MN/GK
15040
24 March 2015

**S.75W MODIFICATION TO HUNTLEE MAJOR PROJECT APPROVALMP_10_0137
HUNTLEE NEW TOWN**

We write to you on behalf of Huntlee Pty Ltd requesting that the Department initiate amendments to Project Approval MP10_0137 pursuant to Section 75W and Clause 12 of Schedule 6A of the Environmental Planning and Assessment Act 1979 (EP&A Act). Specifically the following amendments to the Stage 1 Project Approval are sought:

Figure 1 – Proposed location of sub-stages to be amended

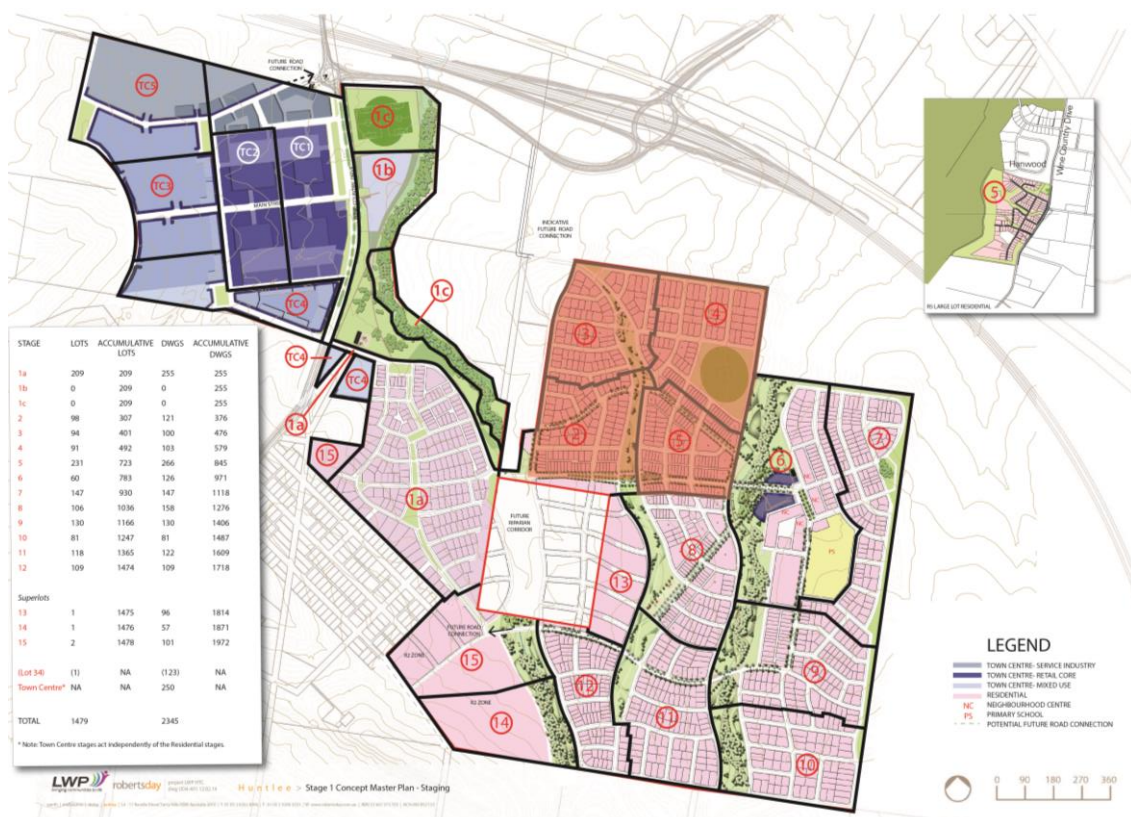
The modification proposes the reconfiguration of the sub-stage 2-5 residential lot layout as a result of the detailed subdivision design to improve the efficiency of road carriageways and increase access and permeability. The residential sub-stages 2-5 are identified on the *Stage 1 Sub-Stage Layout Plan* below in **Figure 1**.

Figure 2 – Proposed subdivision layout plan, Sub-stage 2-5

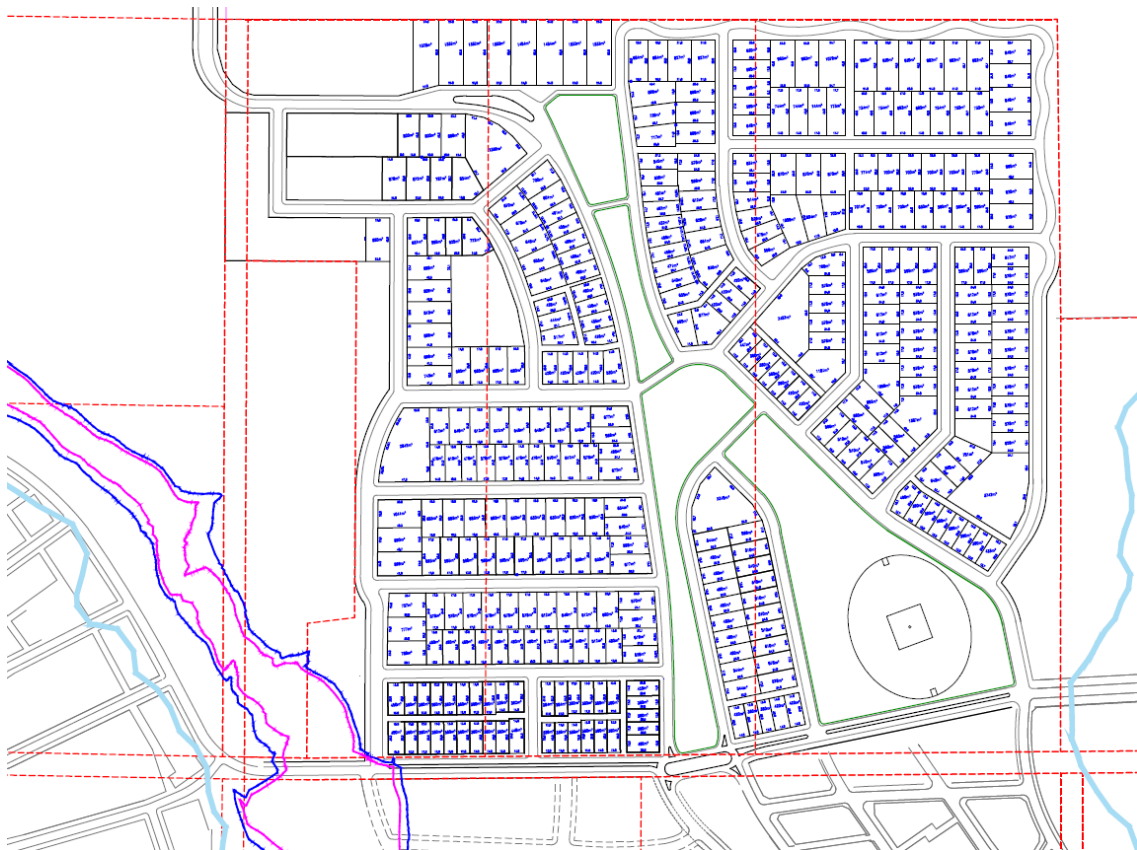
As previously stated, the reconfigured lot layout is a result of the detailed design of sub-stages 2-5. The modified lot layout is shown in **Figure 2** below and a site wide Masterplan is provided at **Attachment A**. The proposed lot layout improves the efficiency of the development by creating more linear street blocks and therefore reducing the required length of roads and improving the legibility and permeability between the residential sub-stages and the Central Ridgetop Park. The proposed subdivision design provides for more contiguous curved street blocks along the Central Ridgetop Park alignment to improve the residential and built form frontage to the Parkside Avenues at the park edges.

The modified lot layout seeks to concentrate smaller lots within close proximity to the Central Ridgetop Park and along major road corridors such as the Central Avenue. The lot layout also seeks to increase the residential density in close proximity to the Village 1 Centre, to the east of the Site, by providing smaller lots in this area and lots to accommodate multi-dwelling housing. The modified lot layout provides larger lots at the precinct boundaries, particularly to the north of sub-stage 3, where longer lots are proposed to enable appropriate space for the inclusion of Asset Protection Zones (APZ) as well as dwellings, as outlined in **Section 3.5**. The proposed reconfiguration of the sub-stage 2-5 precinct will include 374 residential allotments. This number is commensurate with the number of lots approved in sub-stages 2-5, as demonstrated in **Table 1** (see **Section 2.5**).

A lot layout plan has been prepared by Roberts Day (see **Figure 2**) and is provided at **Attachment A**. The plan demonstrates that the 100 Year Flood Extent and the Flood Planning Level (100 Year Extent +0.5m freeboard) will not encroach on any of the modified residential allotments. In addition to this, the modified lot layout will not have any significant impact on stormwater runoff as there are no stormwater detention basins located within sub-stages 2-5.

Figure 4 – Proposed lots to be modified within sub-stage 1
Source: Daly Smith

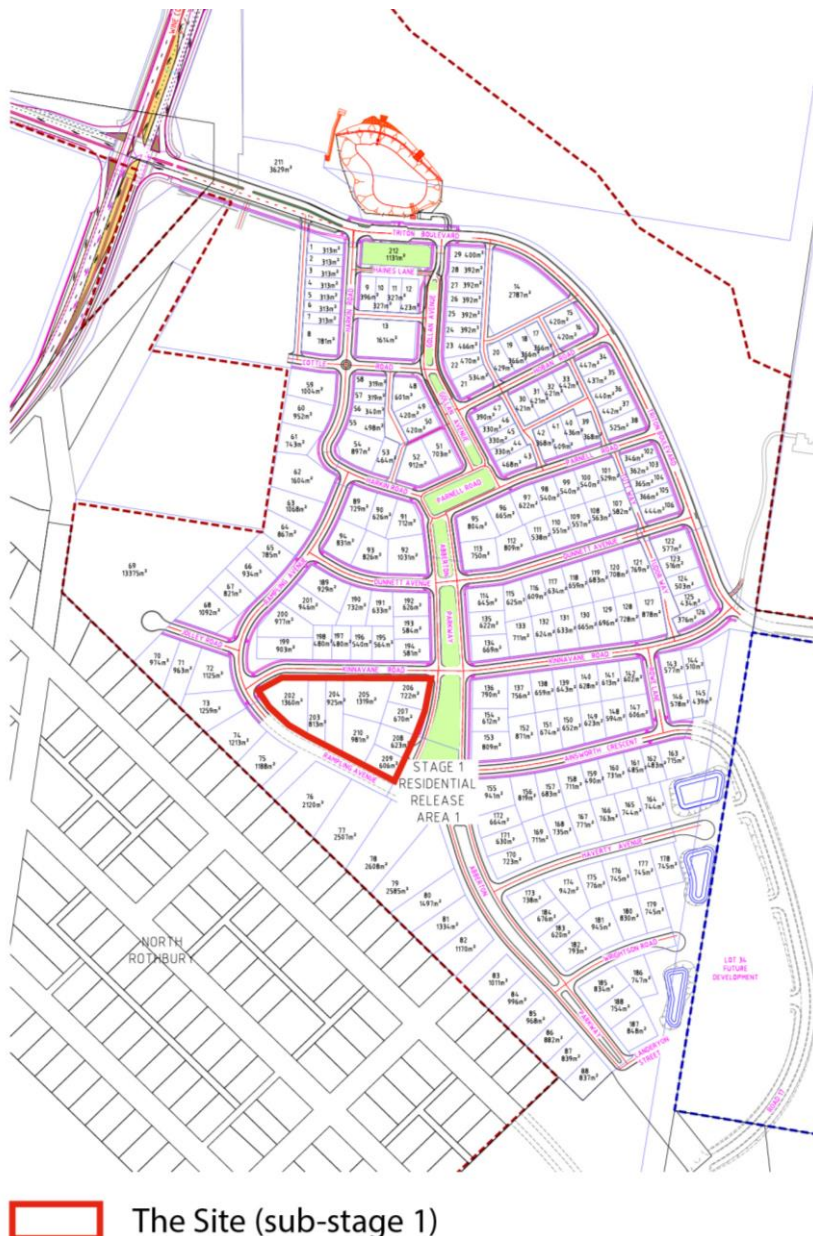
In addition to the reconfigured lot layout in sub-stage 2-5, the modification seeks to amend the layout of 7 lots within sub-stage 1. The sub-stage 1 lots proposed to be modified are identified below in **Figure 4**.

Detailed subdivision plans for the sub-stage 1 lots are provided at **Attachment F** and are also shown in the Site-wide Masterplan (**Attachment A**). The modified lot layout reduces the number of lots within the street block from 11 (approved) to 9 (proposed). The proposed lots are increased in size to provide a greater level of amenity and allow for future development that may include duplex homes or attached dwelling houses.

The proposed modification to the sub-stage 1 lots is internal within the street block and will not have any impact on the street alignment or the streetscape outlook.

Figure 6 – Required Bushfire Asset Protection Zones
Source: RPS

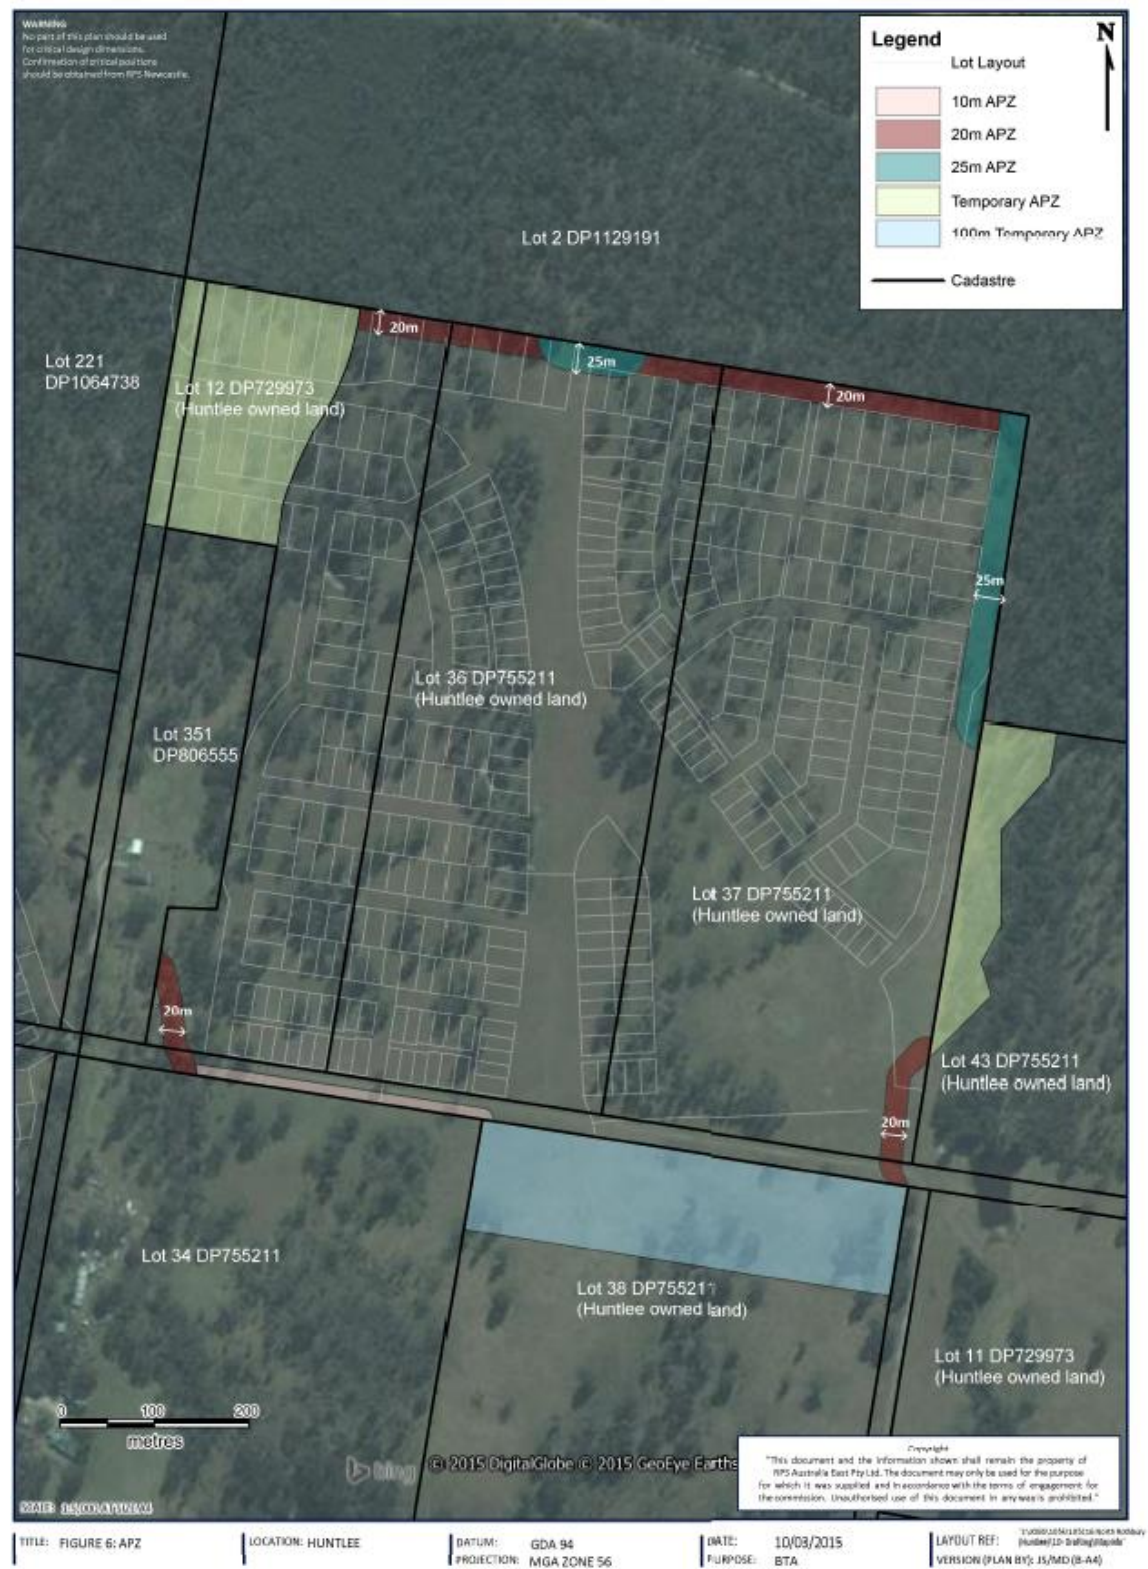
A Bushfire Threat Assessment Report (BTA) has been prepared by RPS and is provided at **Attachment D**. The BTA provides an assessment of the potential bushfire impacts on the sub-stage 2-5 residential allotments and access roads. The Assessment provides a slope assessment for a distance of 100m around the Site and an assessment of the surrounding vegetation and future land uses. The BTA provides that the site is located on bushfire prone land and contains Category 1 and 2 Vegetation as well as Vegetation Buffer lands. The Assessment recommends the implementation of Asset Protection Zones APZs and various other fire mitigation and control measures (see **Figure 5**) as outlined below:

- A 20 m wide Asset Protection Zones (APZ) is recommended to the north (in part) and east of the site between the hazards and proposed development. The APZ on the northern boundary

of the Site will be accommodated within the residential allotments and will be registered to the lot title and maintained by the land owner. These lots are large enough to comfortably accommodate the APZ and a dwelling house;

- A 25m APZ is recommended to the north (in part) and the north east of the site between the hazards and proposed development. This APZ will be accommodated within road carriageways and larger residential allotments;

- A 10m APZ is required between the hazard on Lot 34 and the site. This APZ is accommodated within the road carriageway;
- Temporary 100m APZs are required to the north west and south on Lot 38. This land will be subject to future urban development and as such will not pose a long term bushfire threat to the Site;
